4. **Project# 1002249**  
10DRB-70271 EPC APPROVED SDP  
FOR BUILD PERMIT
- MIKE JACKSON agent(s) for SRI HOLDINGS LLC request(s) the above action(s) for all or a portion of Lot(s) , Block(s) , Tract(s) F-2-B-2, **AMERICAN SQUARE Unit(s)** , zoned C-2, located on CARLISE BLVD NE BETWEEN CLAREMONT AVE NE AND MENAUL BLVD NE containing approximately .52 acre(s). [REF: 10EPC-40038] (H-16) **THE SITE PLAN FOR BUILDING PERMIT WAS APPROVED WITH FINAL SIGN OFF DELEGATED TO TRANSPORTATION FOR PARKING ENCROACHMENT AGREEMENT AND TO PLANNING FOR 3 COPIES OF THE APPROVED SITE PLAN.**

DRB Application No.: 10DRB-70771 Project # 1002249  
Project Name: American Square  
Agent: Mike Jackson Phone No.: \_\_\_\_\_

TO: Jack Cloud, DRB Chair  
FROM: Randall Falkner, Planner  
SUBJECT: Project # 1002249

SITE PLAN FOR BUILDING PERMIT

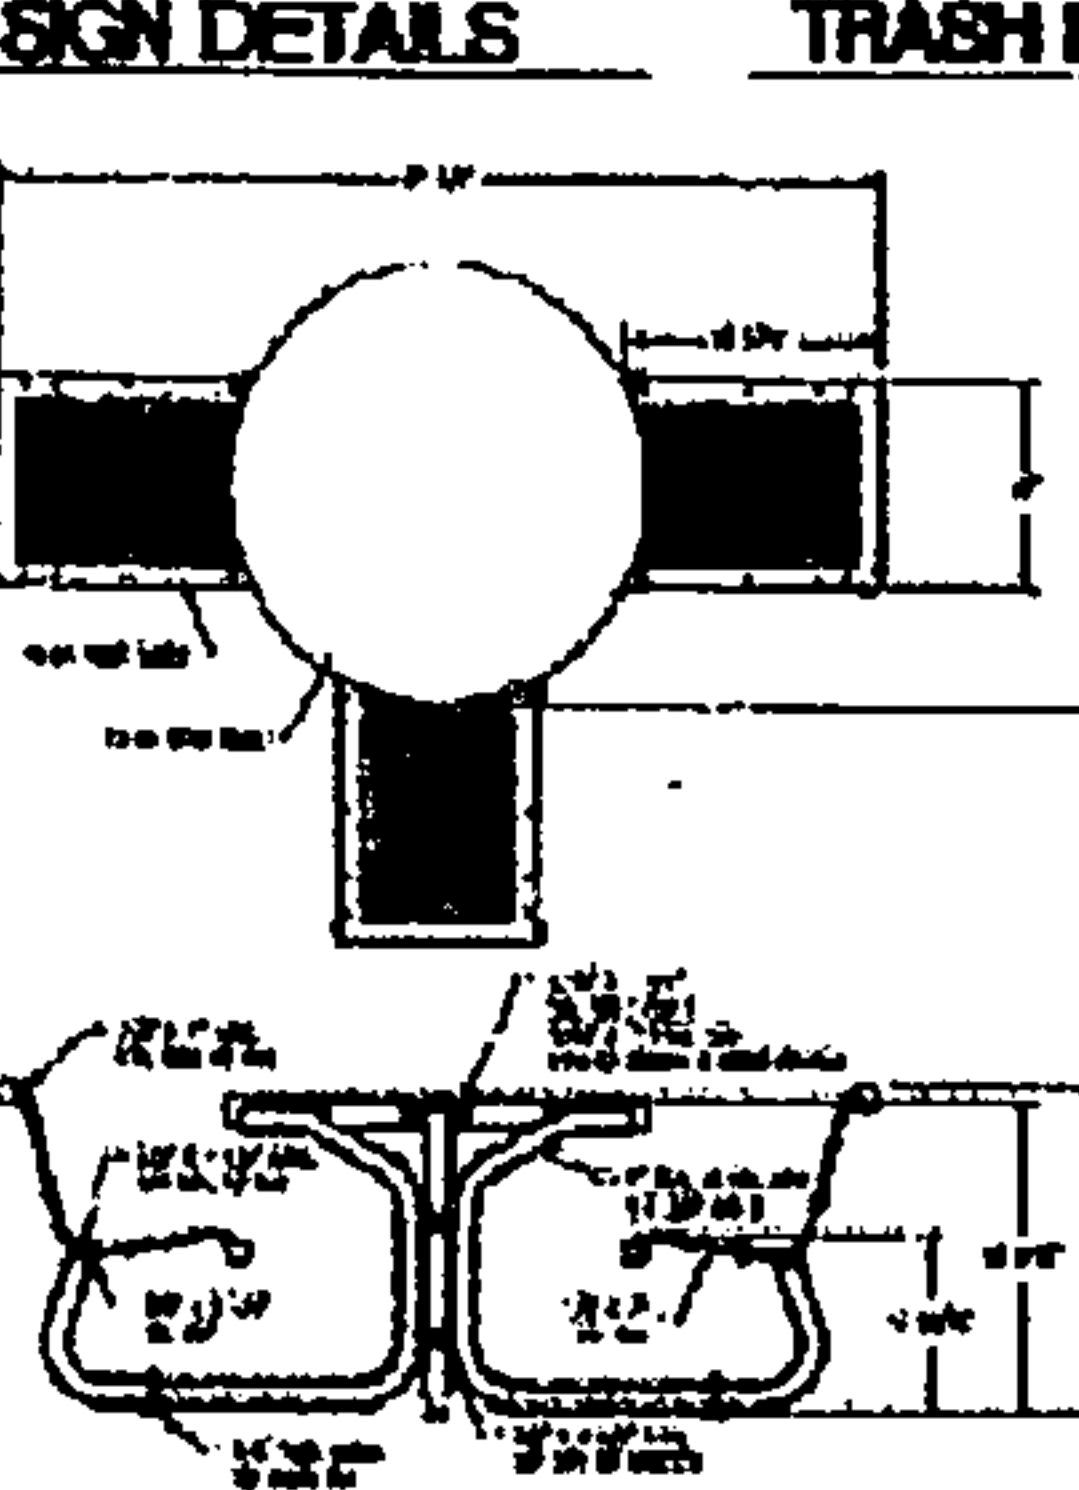
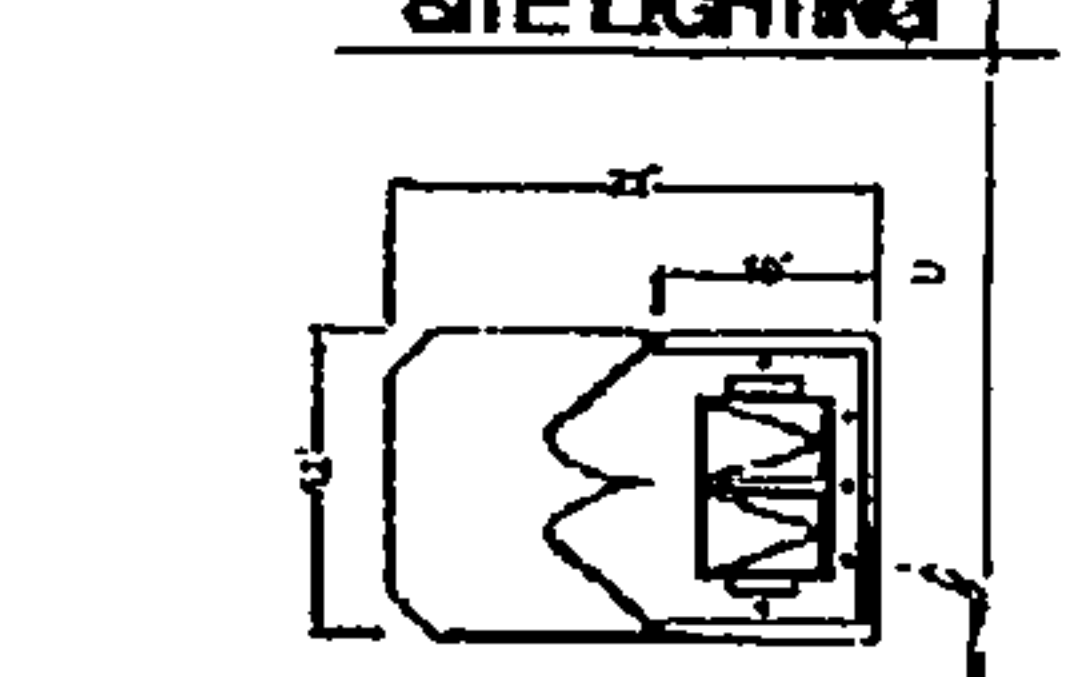
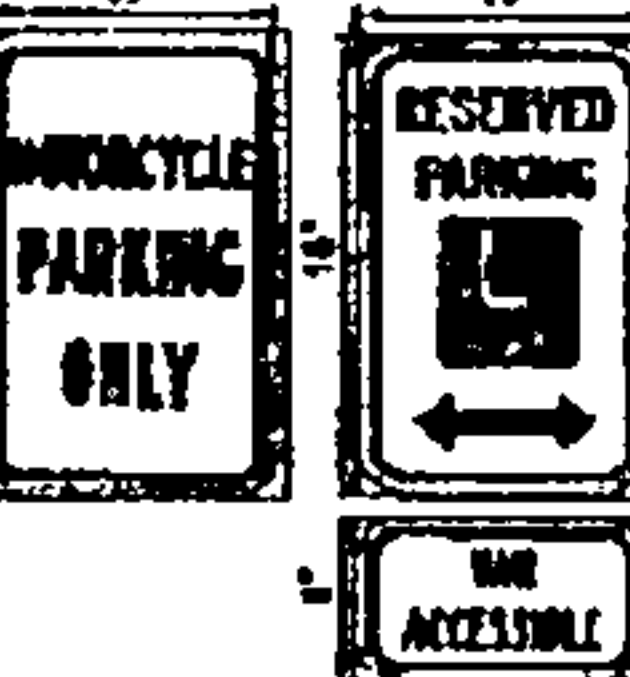
5. The refuse enclosure needs to be rotated to meet SWMD requirements. This has been done and the site plan has been approved by SWMD.
6. Note 12 shall be revised as follows: "Building elevations and information are shown on the attached elevation sheet A2.0. This has been done.

7. The symbol for Keynote 2 shall be removed from west of proposed building. This has been done.
8. Condition 8 was related to cleaning up the keynotes to eliminate some duplicates and some that were not used. The keynotes have been revised and renumbered as requested.

9. Keynote 20 shall be revised as follows: 6 foot wide pedestrian crossing with patterned colored concrete to connect to existing pedestrian route. This has been done.

10. The SDP for building permit shall show the entire site boundary. The plan sheet has been modified to include the entire property line.
11. The SDP shall show a detail for the dimensions of the proposed table and chairs. A detail has been added.

12. The elevations sheet (A2.0) shall show the common name colors of the building. This has been added.
13. Landscaping:
  - a. The symbol for Keynote 9 (on the SDP for building permit) shall be added on the east side of the building. This has been added.
